Action Items 26 and 27:

26	Principles of MPCP	144.3.1	144	31	Glen
27	Delay variability	144.3.1.2	147	46	Glen and Duane

144.3 Multipoint Control Protocol (MPCP)

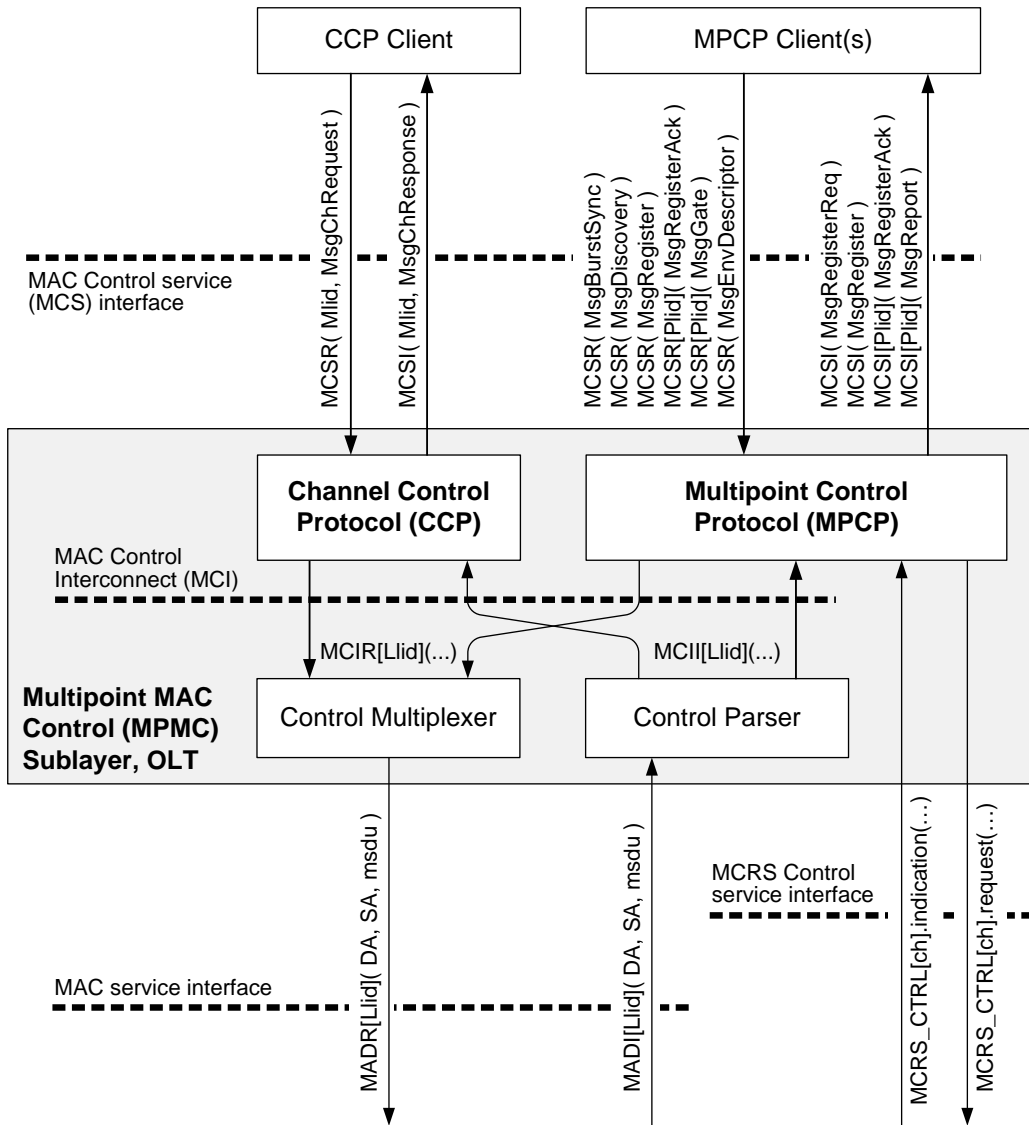
Editor’s Note (to be removed prior to publication): Action item for Glen come up with a new way to show MPCP and CCP for Figure 144-3. This will be submitted as comment against next version of a draft.

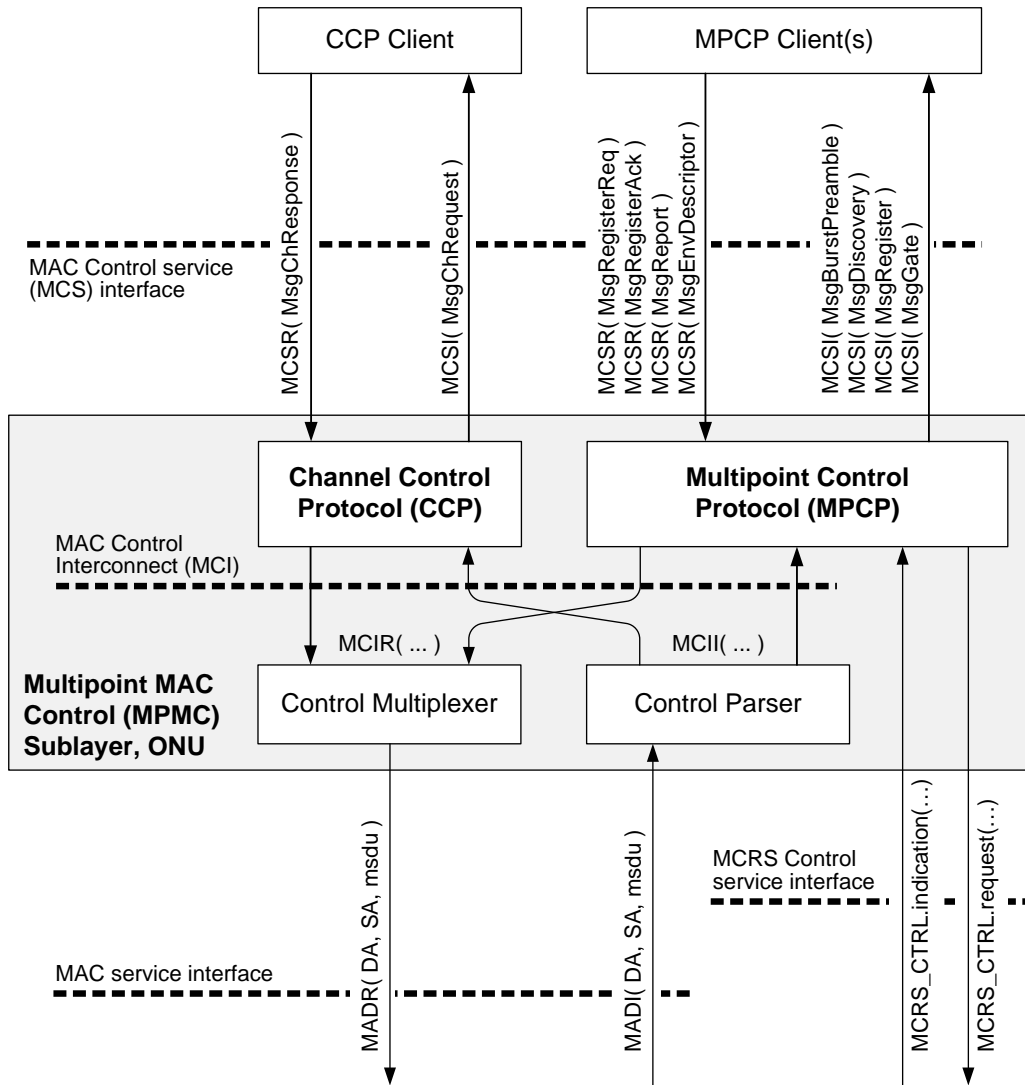
Editor’s Note (to be removed prior to publication): Action item for Glen come up with a new way to show MPCP and CCP for Figure 144-4. This will be submitted as comment against next version of a draft.

-
- 1) Replace figure 144-3 with the following block diagram:**

Figure 144-x – OLT Multipoint Control Protocol (MPCP) functional block diagram

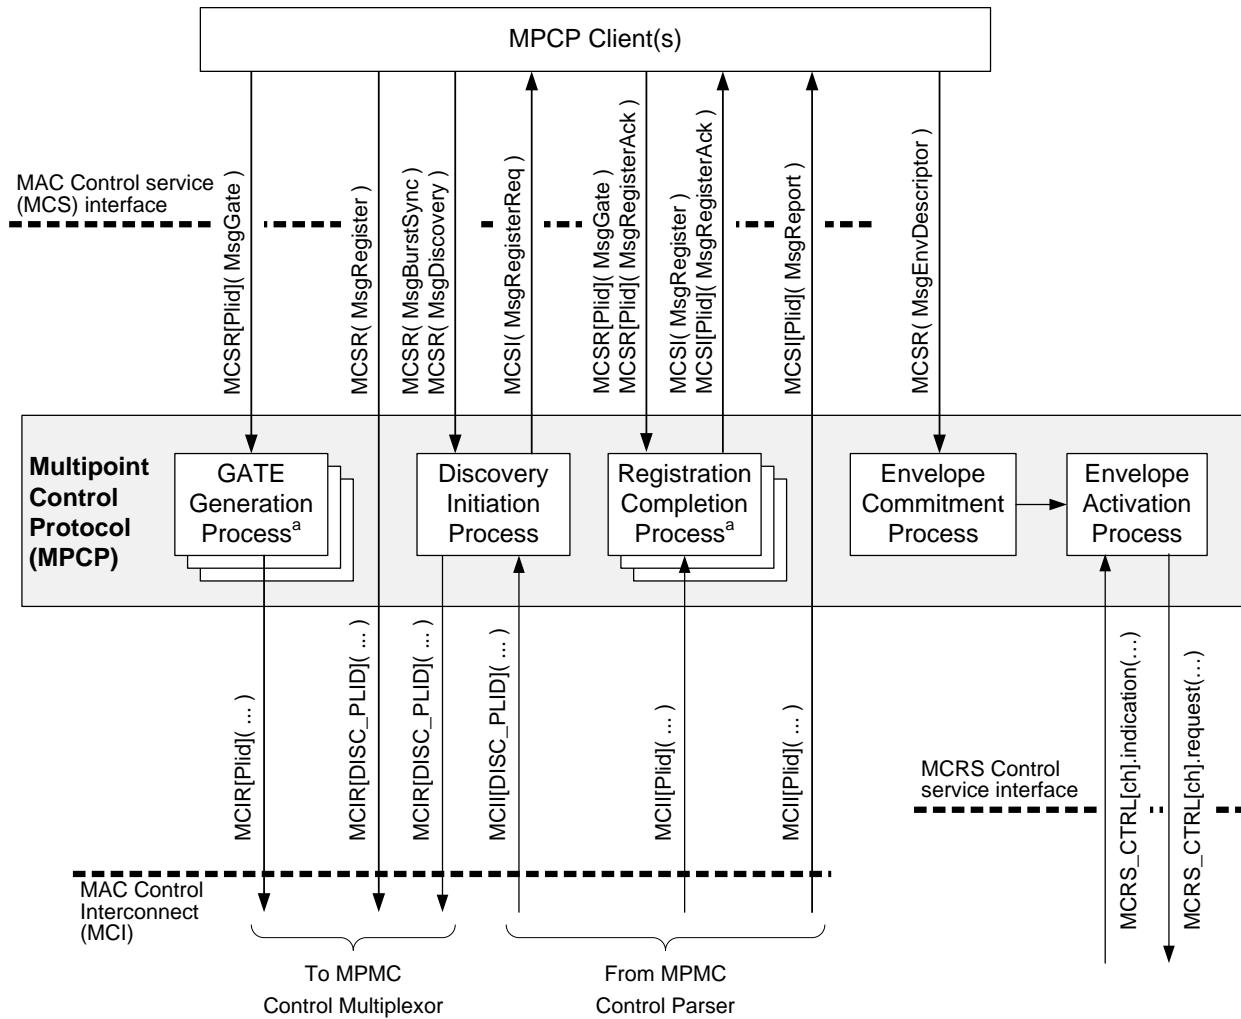
Figure 144-x illustrates a functional block diagram of the Multipoint Control Protocol (MPCP) for the OLT. The MPCP in the OLT includes the following processes:

- GATE Generation Process (see 144.3.6.7)
- Discovery Initiation Process (see 144.3.5.6)
- Registration Completion Process (see 144.3.5.7)
- Envelope Commitment Process (see 144.3.6.9)
- Envelope Activation Process (see 144.3.6.11).

In the OLT, as separate instance of GATE Generation Process and a separate instance of Registration Completion Process is created for each registered ONU (PLID, see 144.3.2).

Figure 144-y – ONU Multipoint Control Protocol (MPCP) functional block diagram

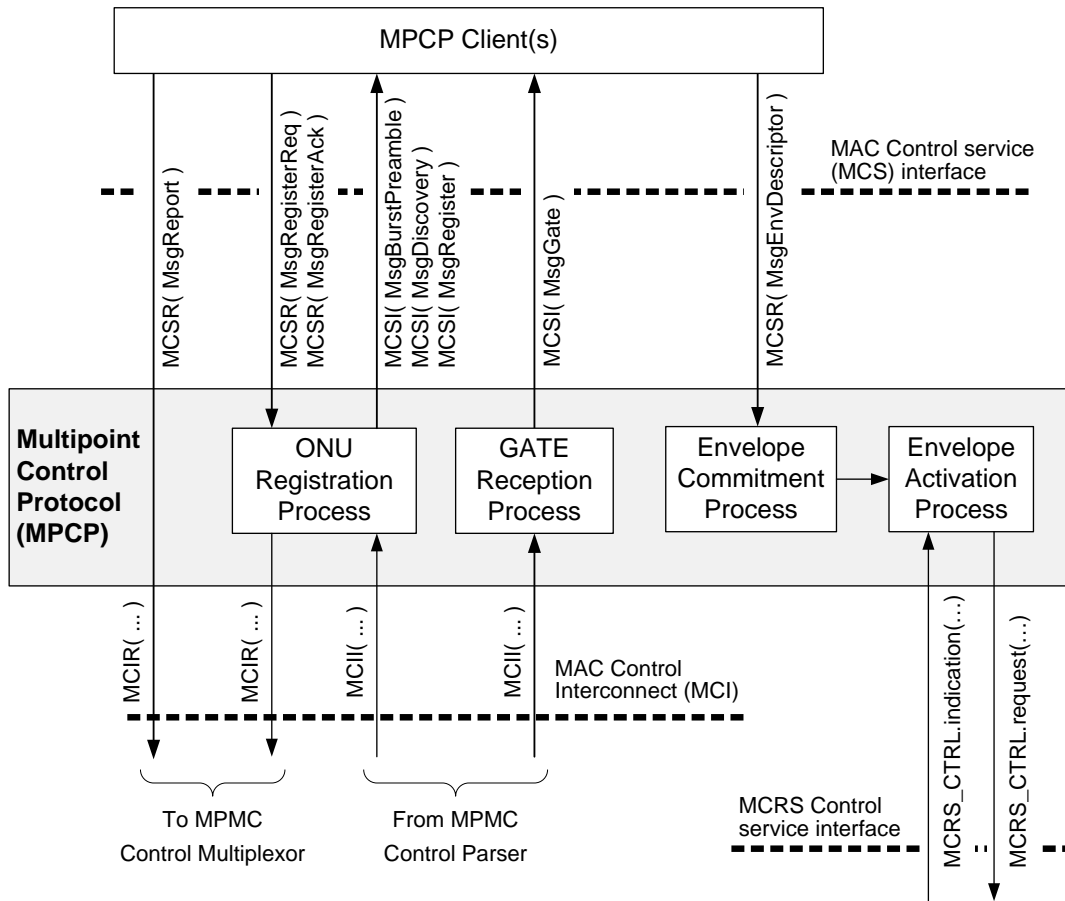
Figure 144-y illustrates a functional block diagram of the Multipoint Control Protocol (MPCP) for the ONU. The MPCP in the ONU includes the following processes:

- ONU Registration Process (see 144.3.5.8)
- GATE Reception Process (see 144.3.6.8)
- Envelope Commitment Process (see 144.3.6.10)
- Envelope Activation Process (see 144.3.6.11).

Figure 144-u – OLT Channel Control Protocol (CCP) functional block diagram

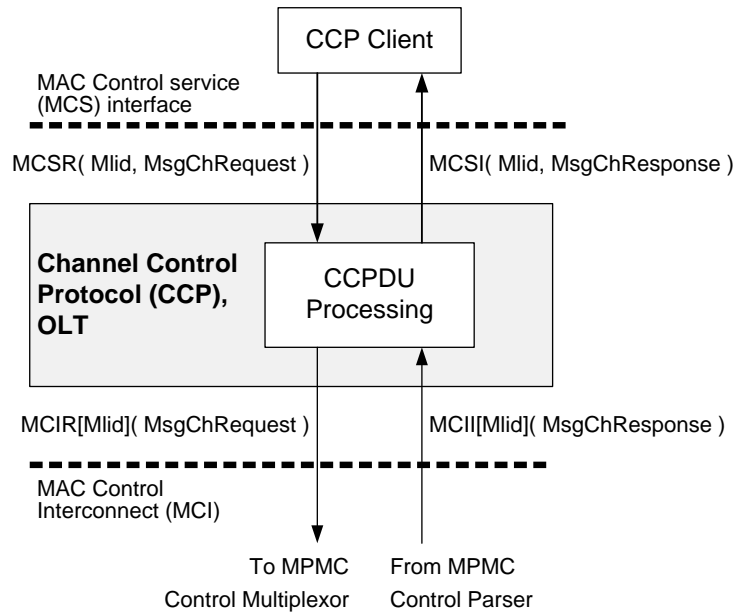
4) Renumber the existing subclause 144.4.1 into 144.4.2. Insert the following new section 144.4.1:

Figure 144-u illustrates a functional block diagram of the Channel Control Protocol (CCP) for the OLT. The CCP in the OLT includes the CCPDU Processing state diagram (see 144.4.3.6).

Figure 144-v – ONU Channel Control Protocol (CCP) functional block diagram

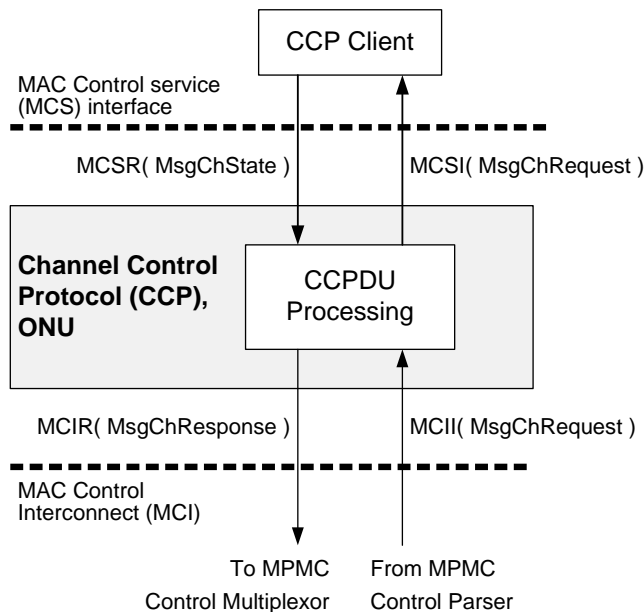
Figure 144-v illustrates a functional block diagram of the Channel Control Protocol (CCP) for the ONU. The CCP in the ONU includes the CCPDU Processing state diagram (see 144.4.3.7).
